Reading Conservation Area Advisory Committee
23 APRIL 2023

101 OXFORD ROAD 230319 & 230320

Reading CAAC object to the proposal to build a new house in the grounds of 101 Oxford Road fronting onto Howard Street.

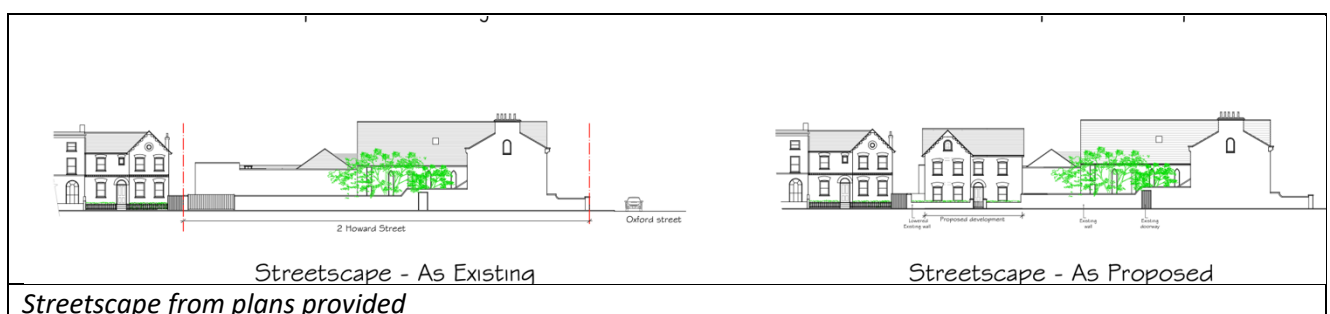
1.1.2 The applicant states in the Heritage, Design & Access Statement (HD&AS) that the new house will be 'totally' on the car park site but the plot for the new house is in fact slightly larger than that. This can be seen in the Block Plan (below) and para 2.04 of the HD&AS ... '2.5m of the soft garden adjacent to the existing car park shall become part of a larger garden/amenity space for the house'. This removes a section of existing garden of 101 Oxford Road for the new property.

1.2.4 The block plan above shows that the building line is matched, but not set back for the front door as is the case for No 2, again this jars.
